DATE: August 18, 2011
TO: All Prospective Bidders

ADDENDUM NUMBER 2

CONTRACT NO. 60-11

**PRIMARY SEDIMENTATION AND
SLUDGE DIGESTION FACILITIES
AND
NEW LABORATORY, OPERATIONS BUILDING
AND ADMINISTRATION BUILDING RENOVATION**

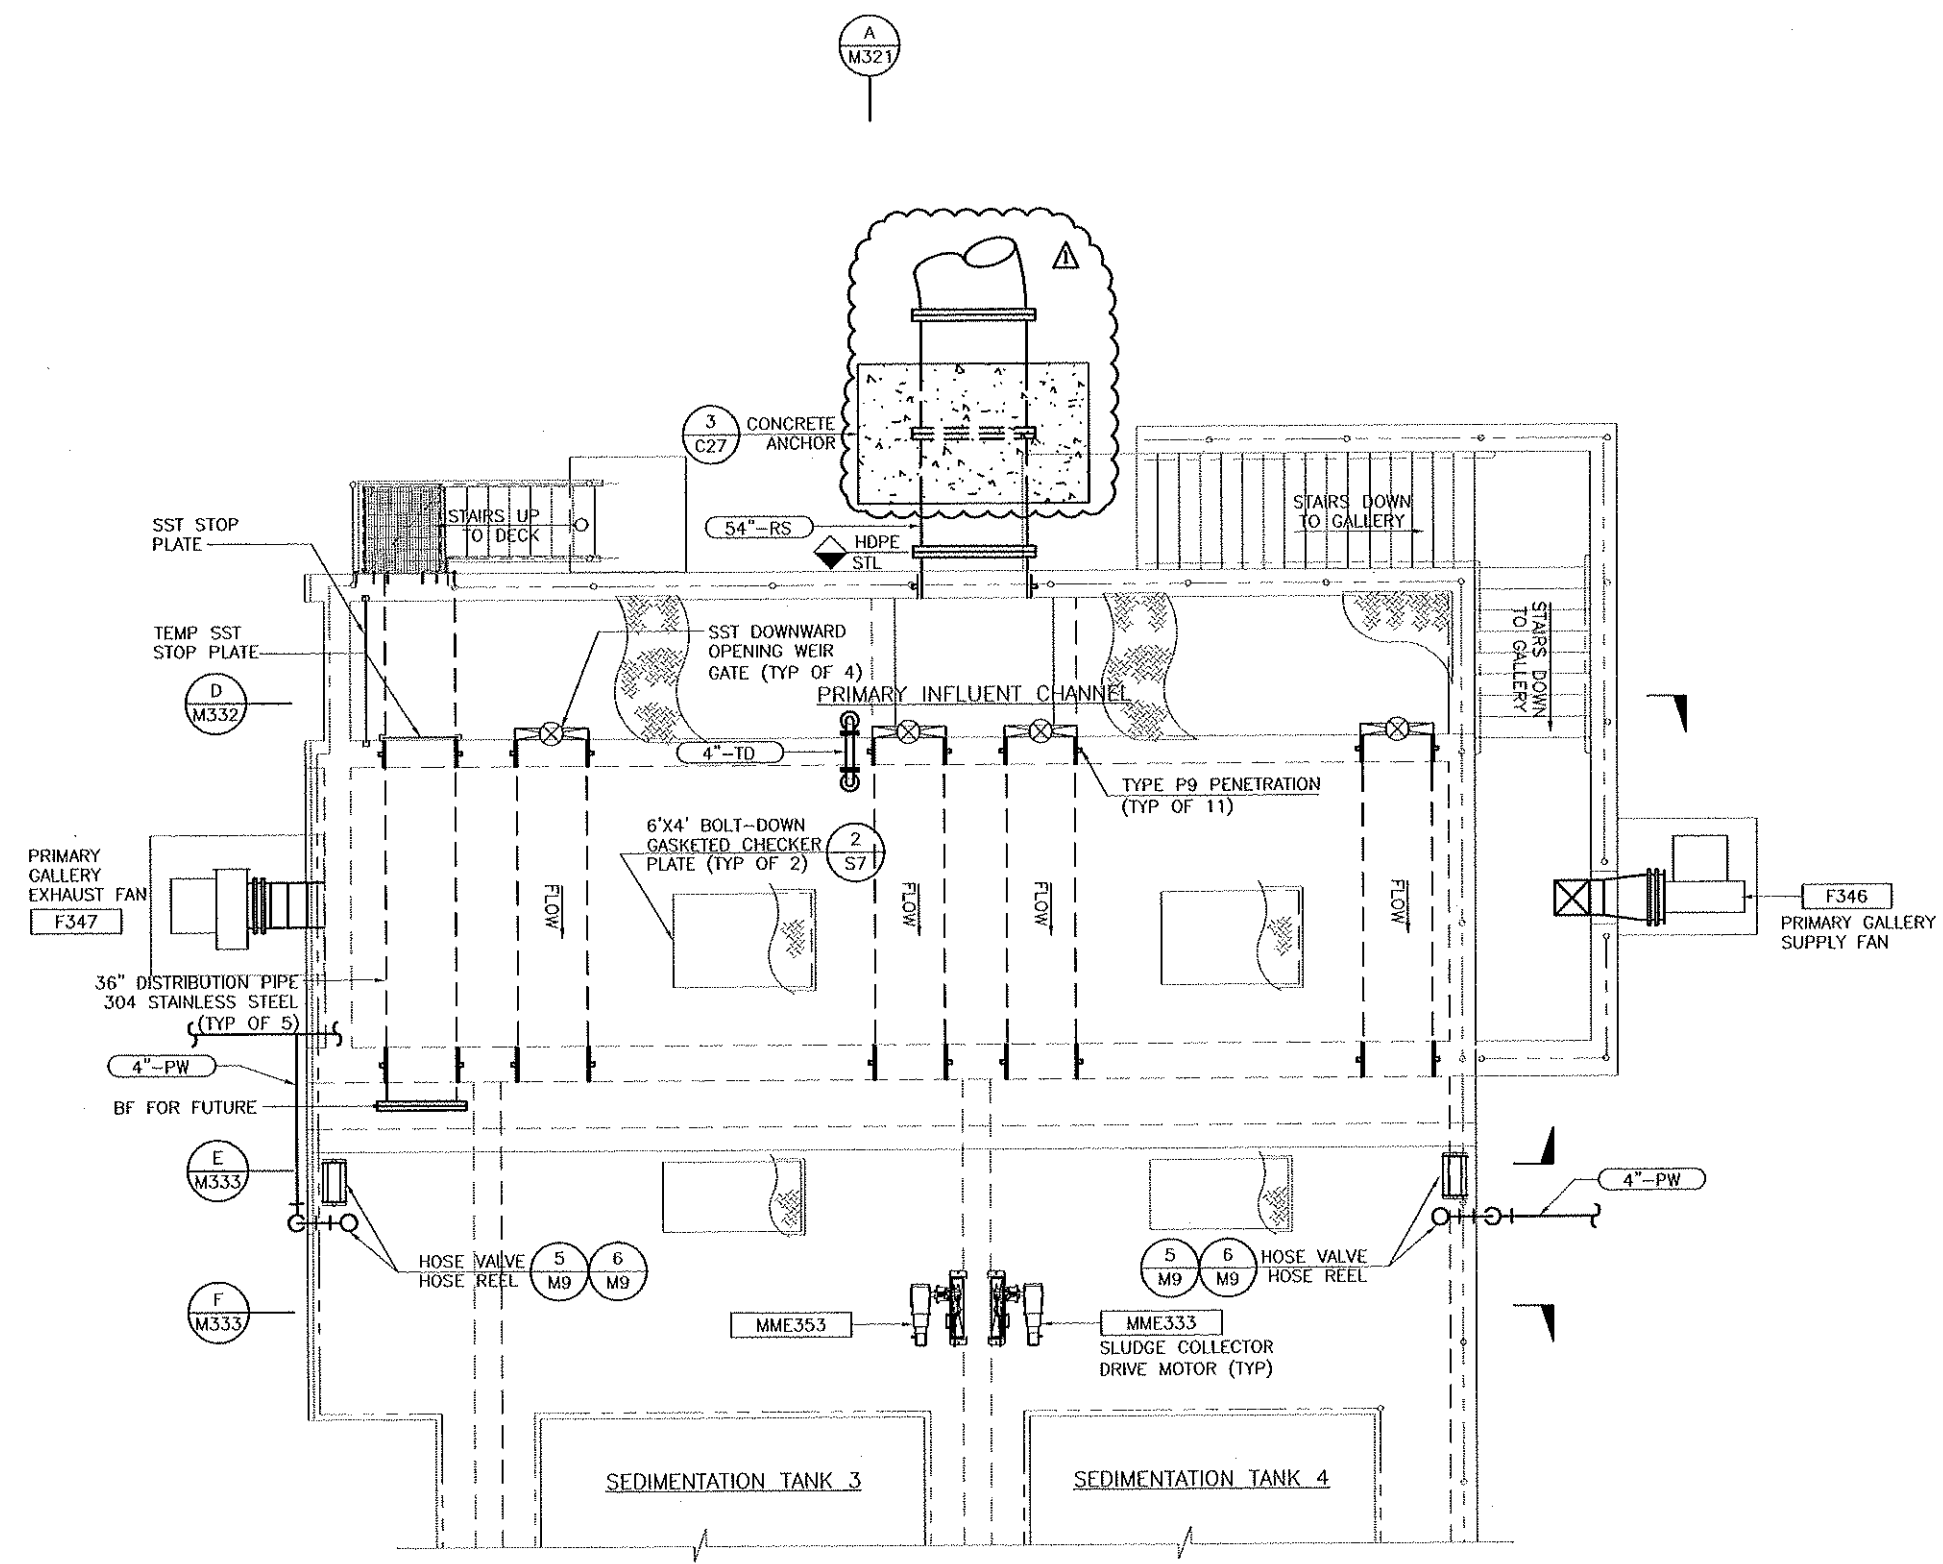
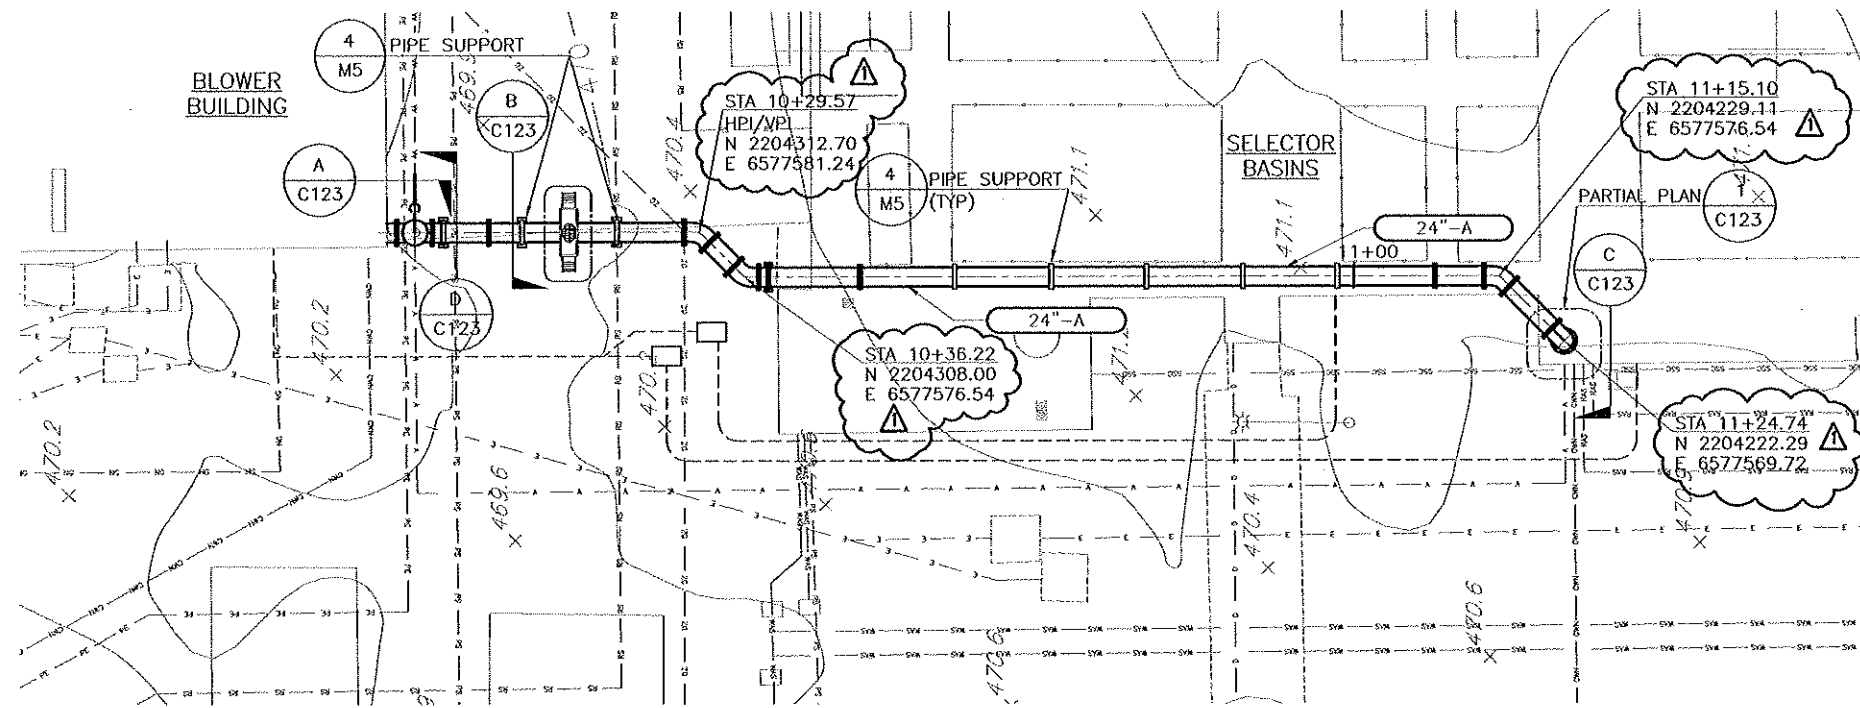
Drawing C122, 24" A pipe lengths based on coordinates do not match pipe stationing or scaled length. Please specify the correct pipe lengths.

Drawing C122 will be reissued.

PRIMARY SEDIMENTATION TANKS
 INFLUENT CHANNEL PLAN

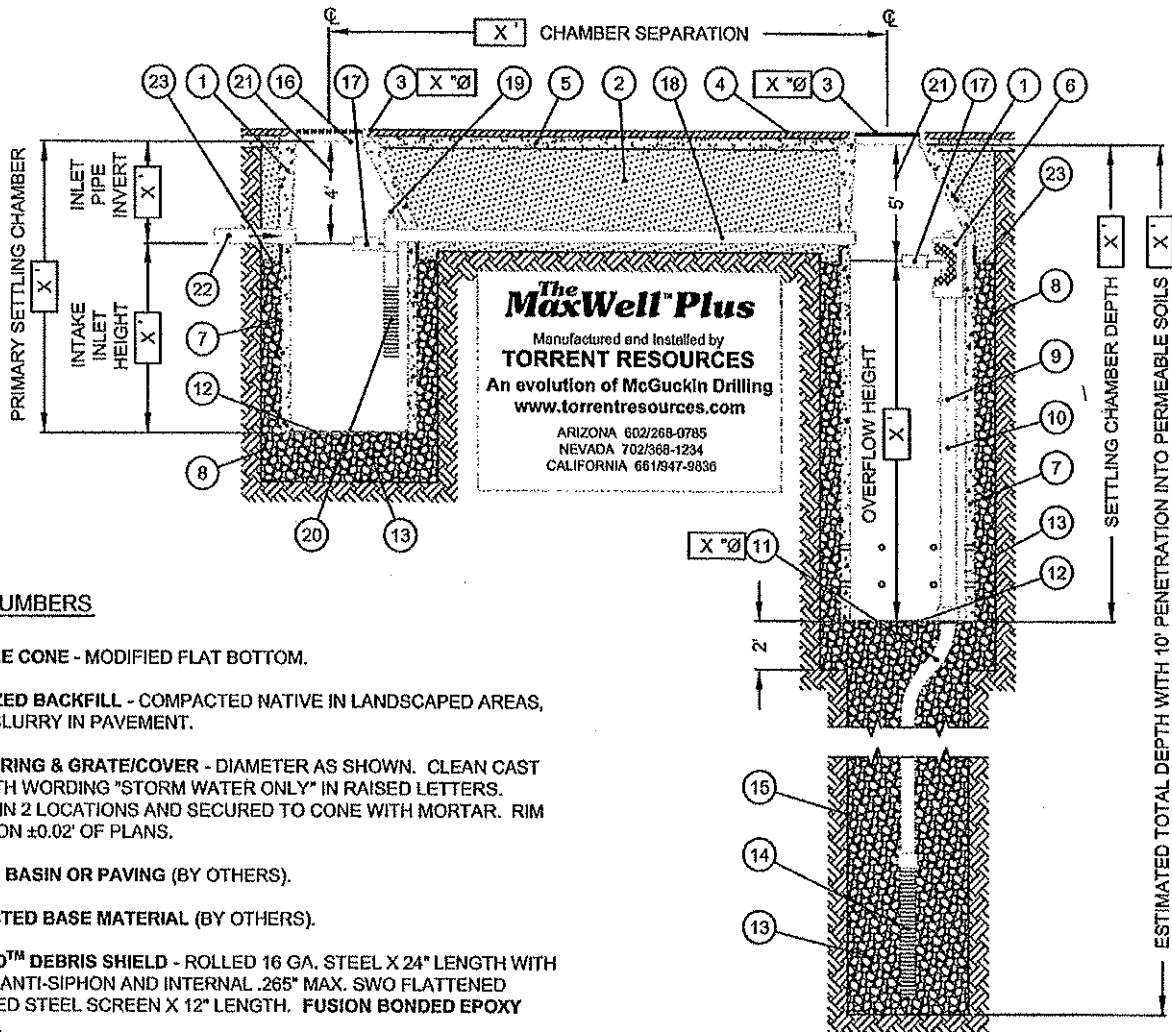
Section "D" on drawing M332 shows side and bottom slots for a temporary bulkhead. Is this one of the 2 ea SS Stop Plate frames specified in Section 11293 for the Influent Channel?

Yes two stop plates are required, one of the influent channel and one for the effluent channel. The stop frame shall be relocated from 36" pipe to Influent Channel on Drawing M330 in line with frame shown on Drawing M332.

Answer 118

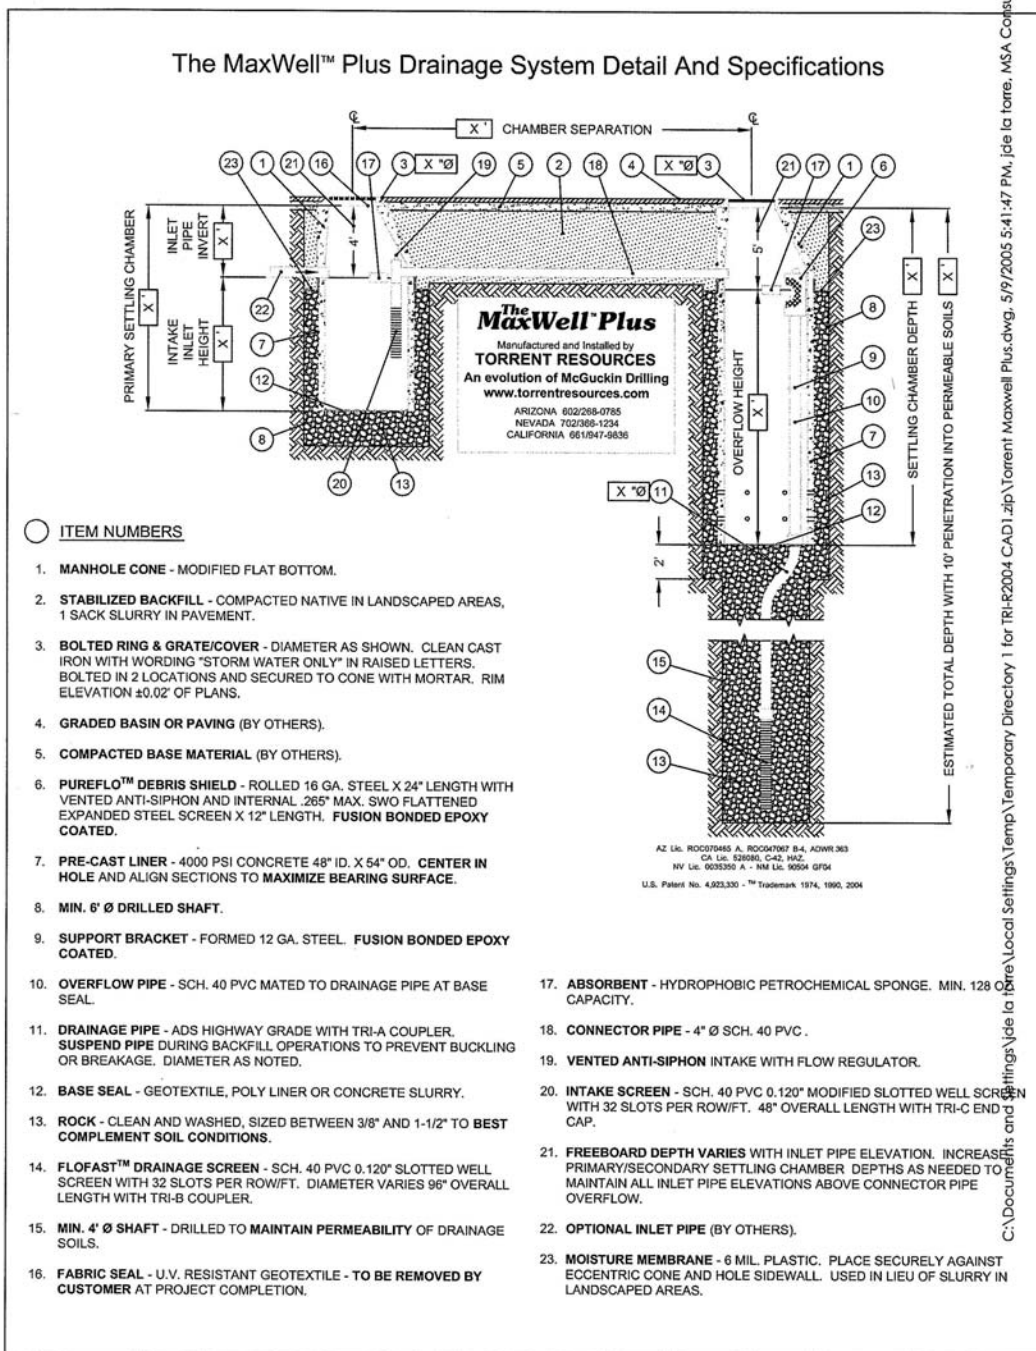
Drawing C-1100r references a "Maxwell Plus" drainage system. The specifications do not define what is required and the drawings outline components that are not defined. Where might the specifications for this system be found?
